KBSO Project #: 24023
Project Name: Noblesville HS AHU Replacements – Bid Pack 2
Issue Date: 10/10/2024

This Addendum number 1 to the drawings and specifications shall supplement, amend, and become a part of the bidding documents, plans, and specifications. All bids and construction contracts shall be based on these modifications to the original contract documents.

MECHANICAL SCHEDULES

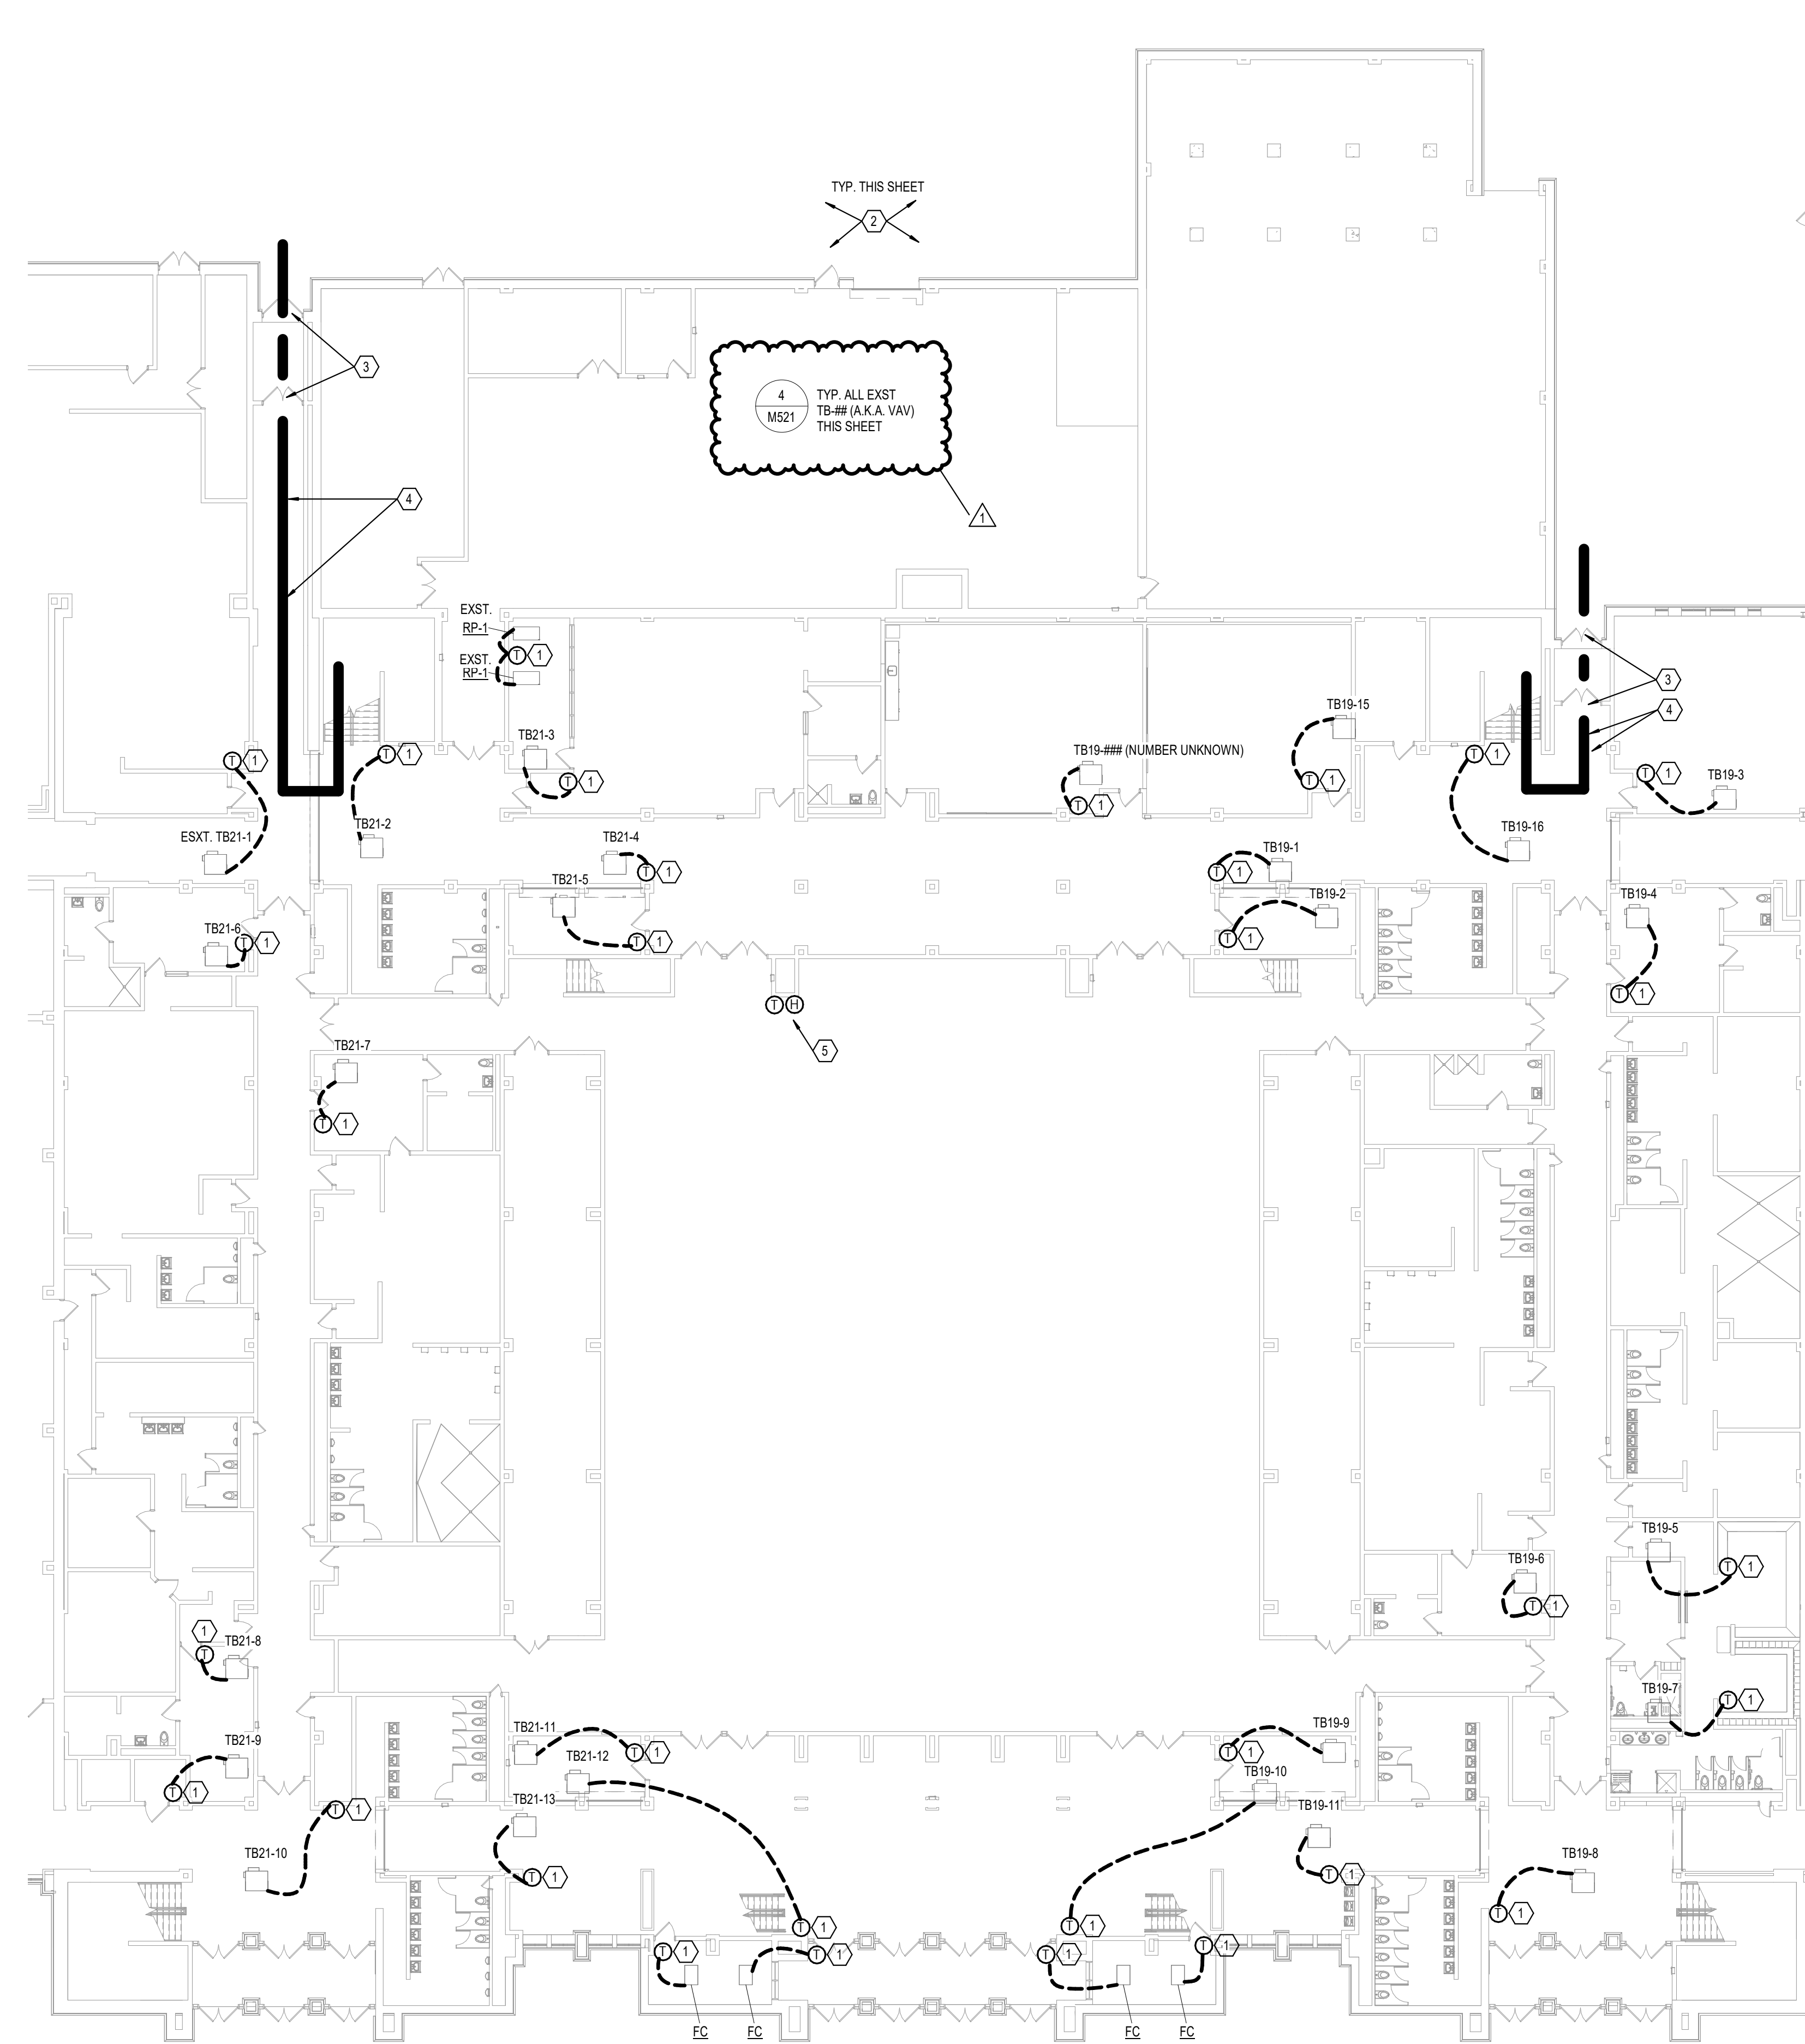
- 3.01 M521 - MECHANICAL DETAILS
 - a. See revised drawings with revision clouds included
- 3.02 M621 - MECHANICAL SCHEDULES
 - a. See revised drawings with revision clouds included
- 3.03 M721 - GROUND FLOOR CONTROLS & LOGISTICS PLAN
 - a. See revised drawings with revision clouds included
- 3.04 M722 - SECOND FLOOR CONTROLS & LOGISTICS PLAN
 - a. See revised drawings with revision clouds included
- 3.05 MD321 - MECH RM M11 MECHANICAL DEMOLITION PLAN
 - a. See revised drawings with revision clouds included
- 3.06 MD322 - MECH RM M12 MECHANICAL DEMOLITION PLAN
 - a. See revised drawings with revision clouds included
